City of Moreno Valley

**Revised Final Program Environmental Impact Report
for the MoVal 2040: Moreno Valley General Plan
Update, Associated Zoning Text Amendments to
Title 9 (Planning & Zoning) and Zoning Atlas
Amendments, and Climate Action Plan**

SCH # 2020039022

**Public Review Draft
September 19, 2025**

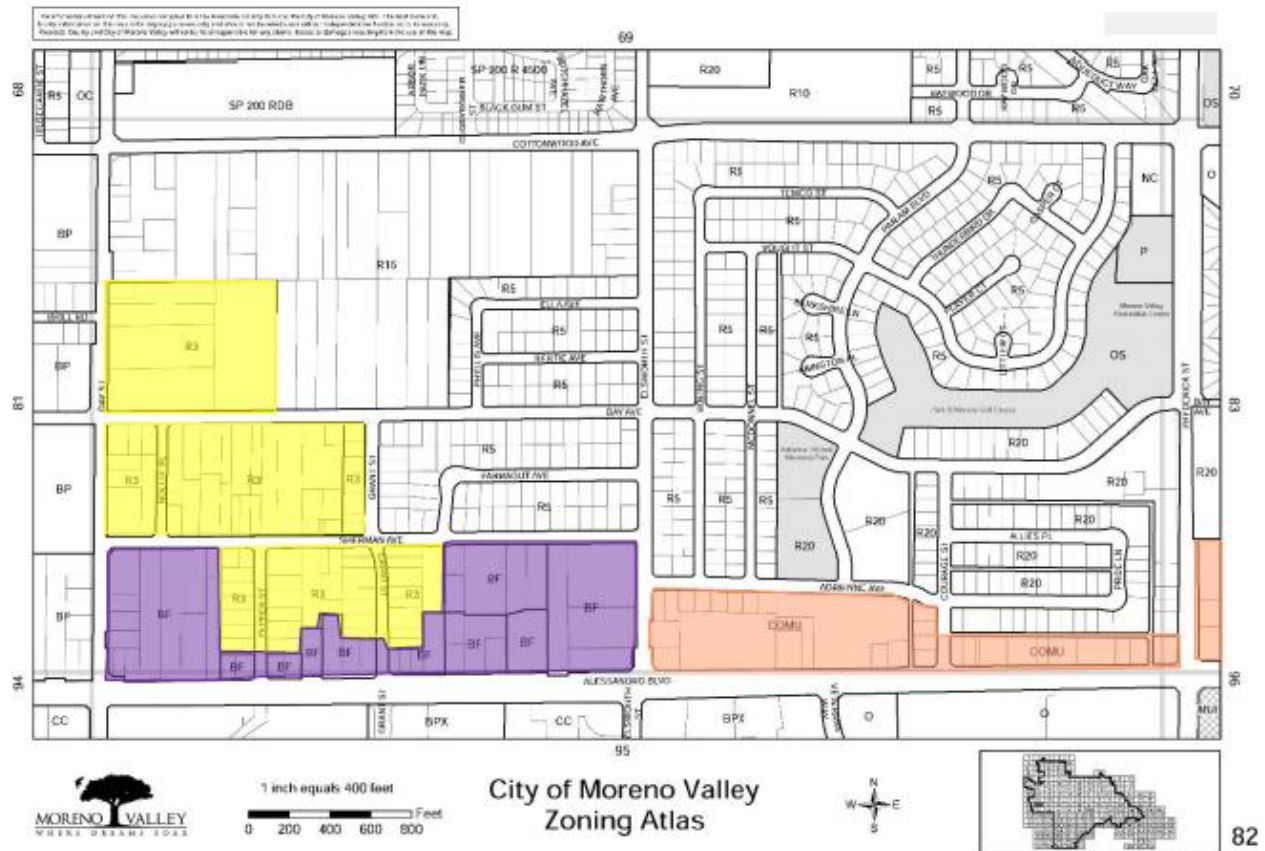
Comment B7-14

The Project would rezone the above purple shaded properties from Commercial and Residential to Business Flex, thereby allowing intense industrial operations in areas immediately adjacent to and nearby to residential zones and existing sensitive uses in the community of Edgemont. (See, Air Quality Study, Figure 1.) This is a Disadvantaged Community that already suffers under extreme “pollution burden” according to the Project’s Air Quality Assessment. (REIR Appendix B, Figure 7, Figure 3, Figure 8). The proposed zone change to allow more industrial operations in this area must be considered in terms of all area of potential environmental impact including cumulative impacts, land use, and environmental justice, with appropriate development conditions and/or mitigation measures adopted to ensure they are carried forward to future implementing projects.

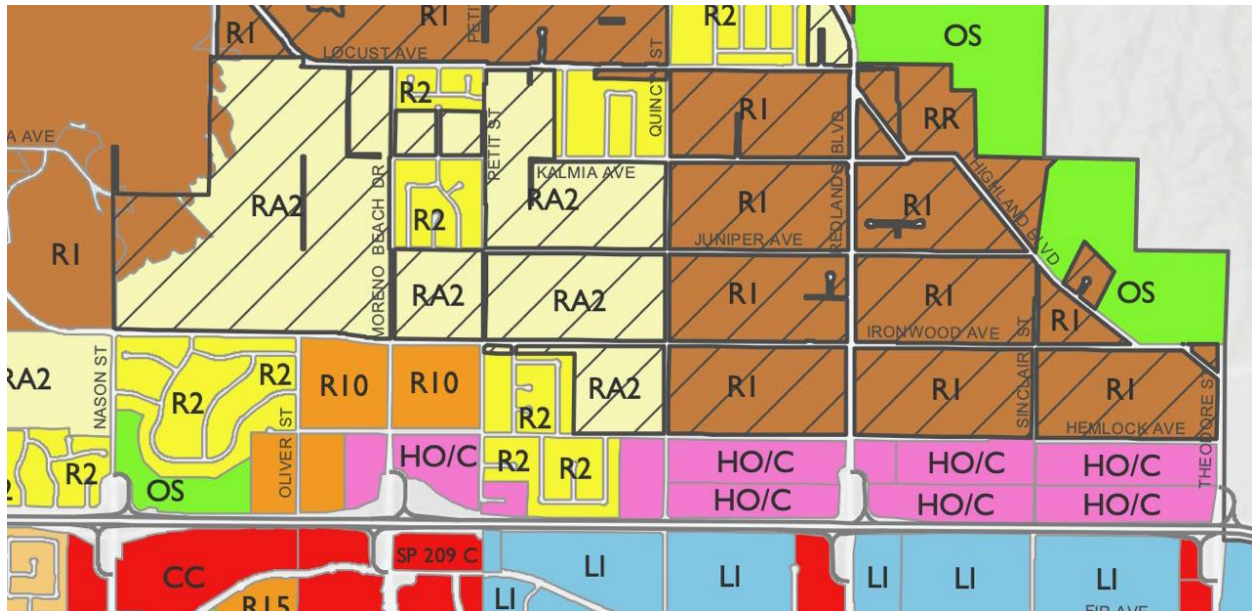
With Aquabella’s 15,000 high density units approved late last year, 1,600 apartments approved in June 2023 for the Moreno Valley Mall redevelopment and 800 units recently approved in the Town Center at Moreno Valley plus other projects approved in the last couple of years our city no longer needs the 10 units per acre (R-10) in the NE to meet its Regional Housing Needs Assessment (RHNA) numbers. **The R-10 in the proposed Revised General Plan Update (GPU) in NE Moreno Valley needs to be removed and replaced with R-2 which is our current zoning because of the court’s judgement.**

Because of the start of Covid in 2020/2021 NE Moreno Valley residents didn’t have the regular GPU meetings as did other parts of the city and their council member died which left them without representation prior/during the votes on the 2021 GPU. Do not accept that R-10 was already approved — NO Council member was in office to represent NE Moreno Valley — because they had died as did the desires of those in the NE Moreno Valley.

The zoning map found below is from the 2021 General Plan that the Courts told the city they had to set aside and not use. **You will soon be asked to simply rubber stamp the same 2021 zoning map again for General Plan Update (GPU).** As you can see the Orange R-10 (ten units/acre) is north of SR-60 and south of Ironwood Ave - on both sides of Moreno Beach Dr. R-1 is one unit per acre and R-2 is two units per acre. They also added C in pink for Commercial north of SR-60 which will significantly impact the R-2 homes in the middle of them — it was and currently is O for Office which has many fewer impacts on families.

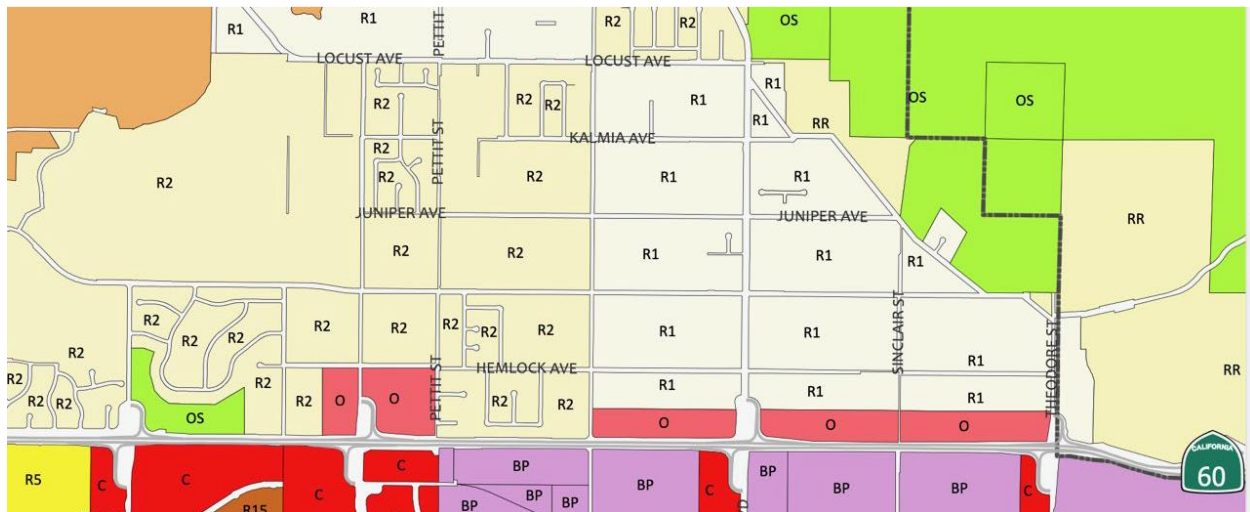
Because the courts told the city to set aside the 2021 zoning we again **enjoy the zoning found below.** There is currently no R-10 in the NE and only O for Office just north of SR-60 which will impact existing families on R-2 in the middle much less than C for Commercial.

The above is the current Zoning in NE Moreno Valley which most in that area are in favor of maintaining. The map at the top was pushed Through In 2021 when NE Moreno Valley families had NO council member representing them because she had died. Please do Not Accept that it was approved by those representing the NE area.

Figure 1. The City of Moreno Valley and surrounding areas within 20 km with warehouses and potential future warehouse projects. Data from Warehouse CITY v1.23 (Phillips and McCarthy, 2024).

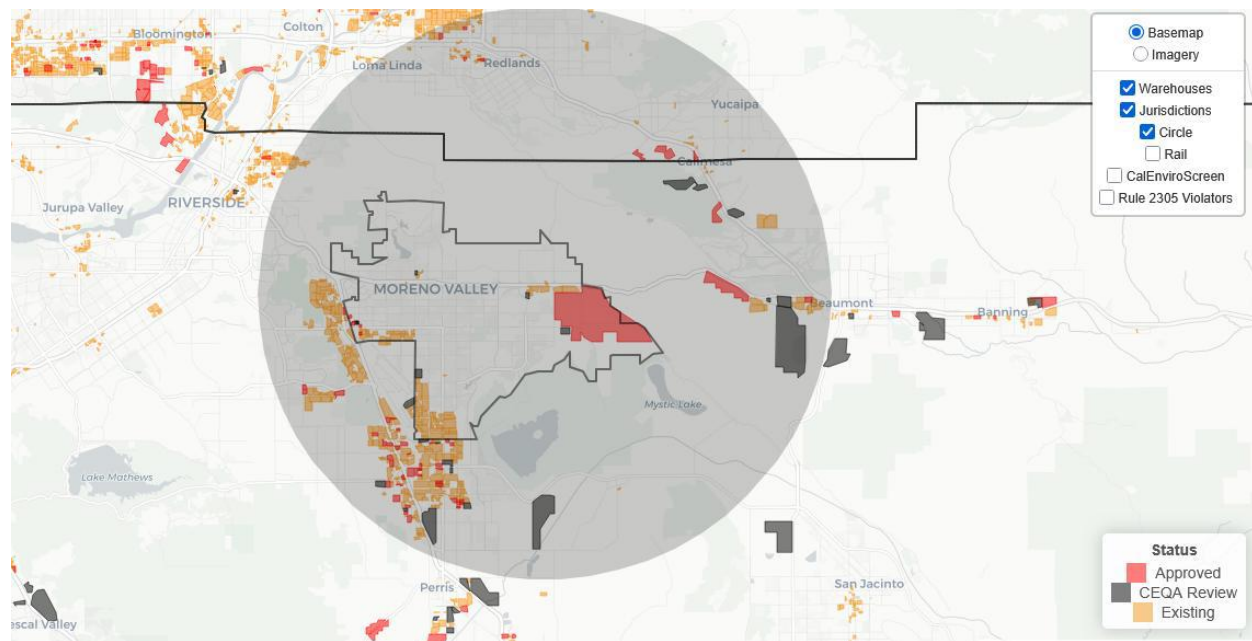
Figure 1 shows warehouse existing and planned development around Moreno Valley in Beaumont, Perris, and other areas. Warehouses don't exist just within Moreno Valley and the industrial land use in the region will cause regional air quality, traffic, GHG, and low-quality jobs problems.

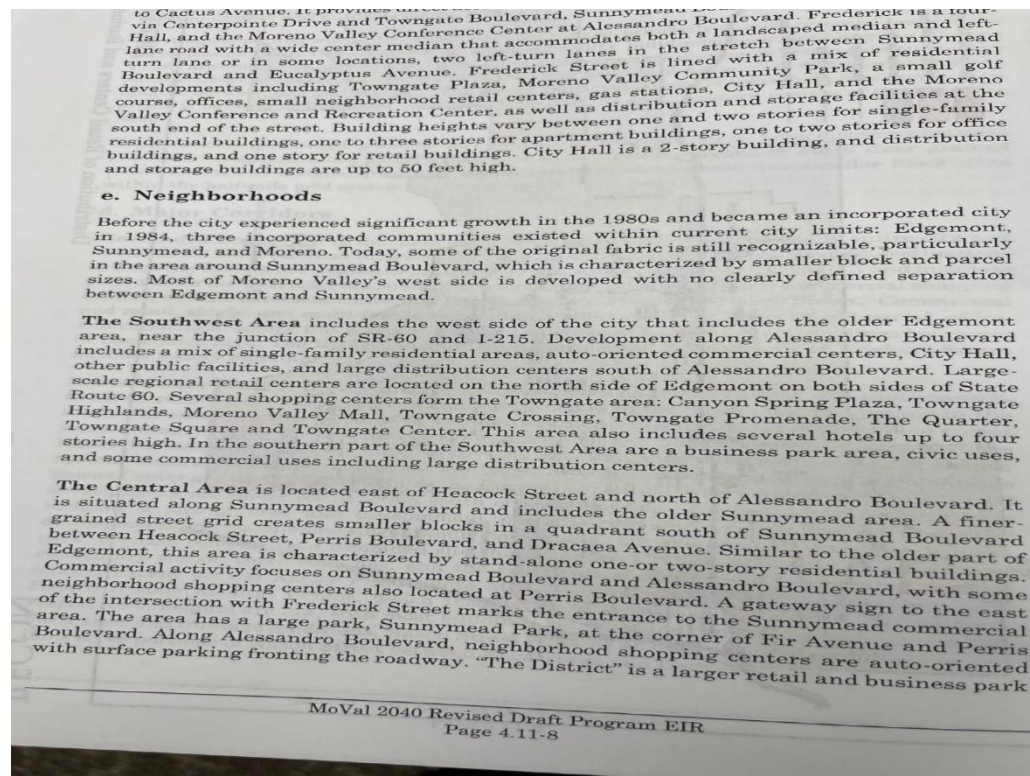
Clearly R10 and commercial do not fit our community character and need to be removed. Dividing our community is also considered a severe negative impact which R10 and commercial both do.

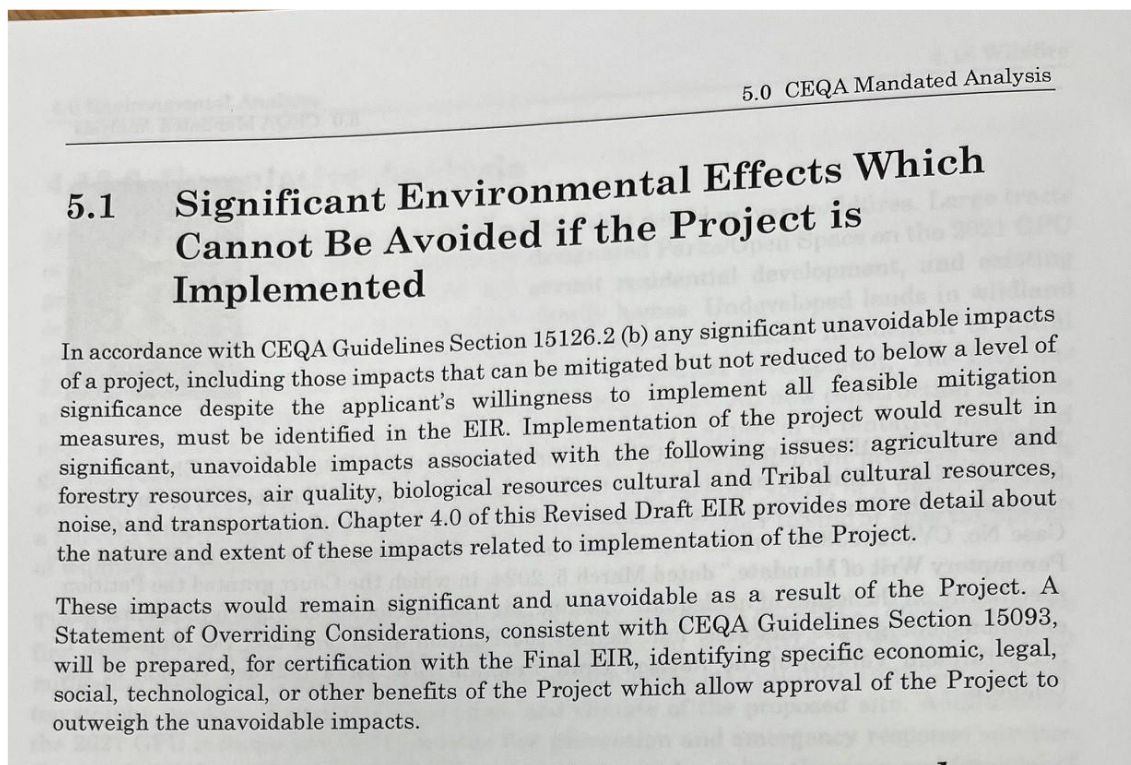
What will the city do differently in our Northeast neighborhood to protect the existing residents from the crime that will follow 24/7 commercial businesses and high-density housing?

Opening Hemlock to through traffic severely impacts the safety of the residents of Sterling Ranch. What is currently a safe neighborhood to walk, bike and jog will suddenly be subject to high-speed traffic and trucks. It's also a very safe neighborhood with only 2 entrances/exits. Our calls for police assistance can go unanswered for over 24 hours- how will that change with high density and commercial?

Fig. 1 Warehouses in MoVal and Other Areas within 15km (from 8/26/24 Comments)

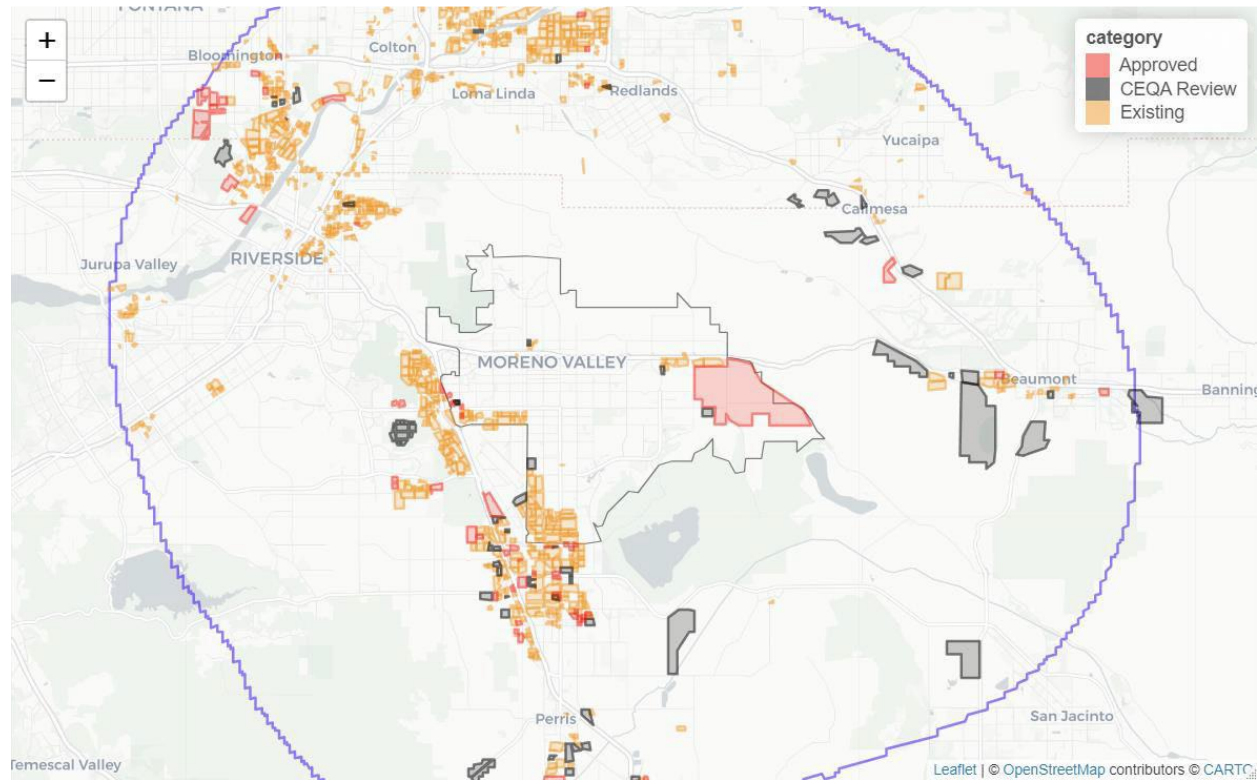
(a) This draft CAP does not clearly explain how the actions proposed to close the gap will fully reverse the existing and new amount of GHG emissions that come from approximately "1076 existing warehouses covering 13,000 acres ... and about 190,000 daily truck trips ... 64 approved warehouse projects ... and 71,000 truck trips ... and 58 warehouse projects under CEQA review ... and 87,000 truck trips." (My underlines, see Fig. 1 below and Mr. McCarthy comments, August 26, 2024) that will impact the Moreno Valley area. Please explain clearly and in sufficient detail in the body of the report your assumptions, modelling and treatment of these existing and upcoming GHG overwhelming emissions, and why such assumptions and treatment are valid. The current pollution and warehouses have already affected our air

quality and our health for years (with impacts clearly and emphatically explained in your draft EIR, digital pps. 142-144), and have caused traffic nightmares along the 60 and 215 freeways.

Fig. 2 Pollution Burden Percentile by Census Block in Moreno Valley (MV IRP, p. 44)

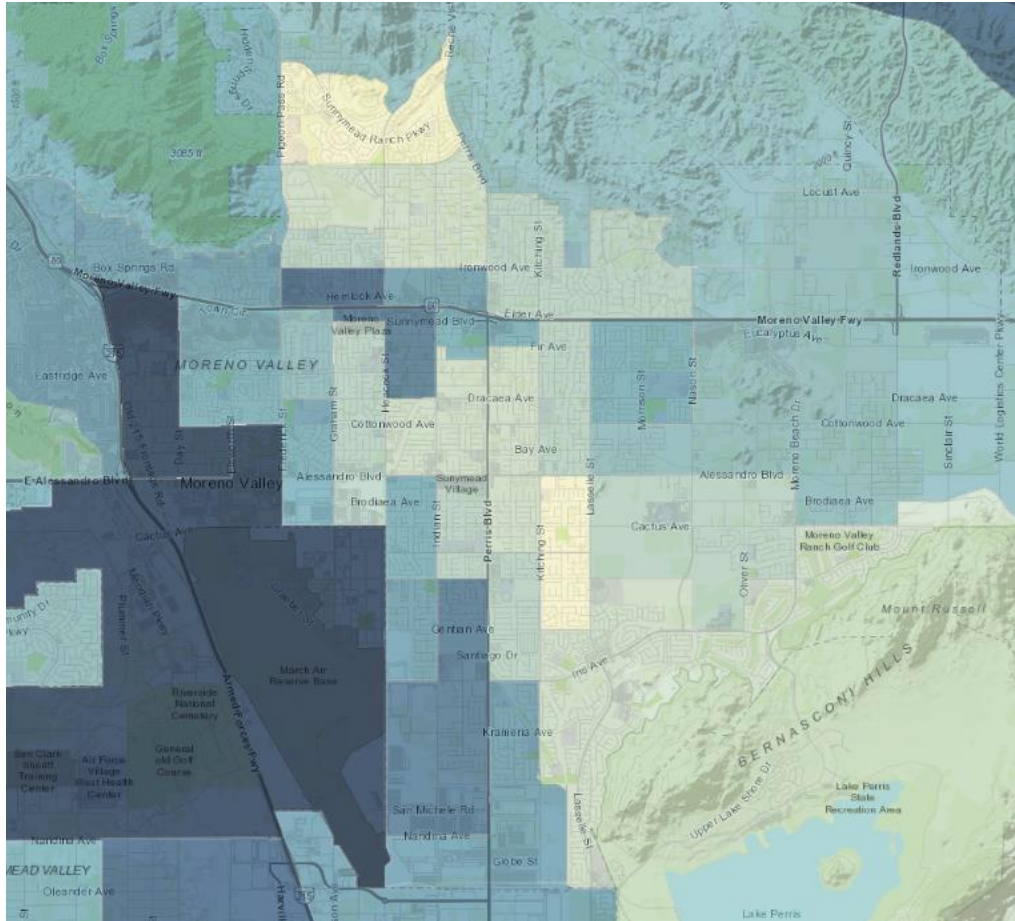
4. Environmental Justice - It is well chronicled in the news that the Inland Empire has one of the worst air qualities in the country, the American Lung Association gives routinely an F for air quality reports, and "Inland residents suffer higher rates of asthma and other ailments linked to air pollution" (The Press-Enterprise, July 30, 2025, p. 6). Although the logistics industry brings needed jobs to the Inland Empire, the pollution from diesel exhaust created by big trucks and freight trains connecting to warehouses is contributing to our failing air quality and health. Fig. 2 below shows the pollution burden percentile for Moreno Valley - you can see that more than 50% of the City has a burden of 50% or higher, which indicates an area that is heavily impacted by pollution and environmental burdens due to its "proximity to highways, industrial operations, and the nearby Air Force base" (MV IRP, p.43)

Fig. 3 Earth Observatory Website (accessed 8/12/25) - Where Warehouses are Built, Air Pollution Follows

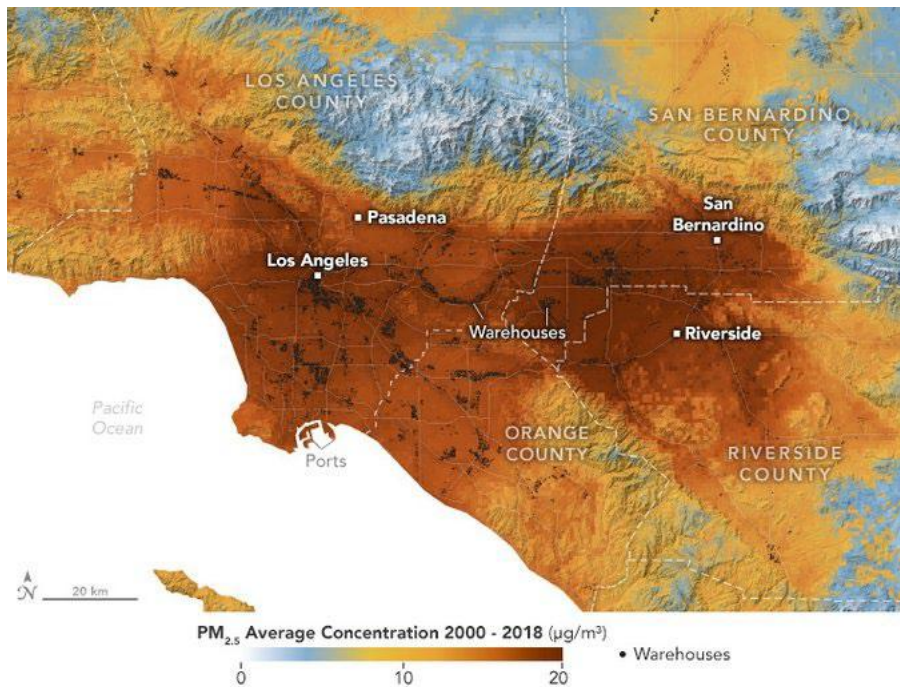
Furthermore, Fig. 3 below confirms what we already know, that "areas with large warehouses, or a large number of warehouses, ha[ve] higher levels of airborne contaminants than those with fewer or smaller warehouses" (The Press-Enterprise, July 30, 2025, p. A6). This proliferation of warehouses and its associated truck and freight rails are the "primary sources of pollutants like nitrogen oxides (NOx) and Particulate matter (PM), which disproportionately impact nearby [Disadvantaged Communities]", and there are already too many of those in the State.
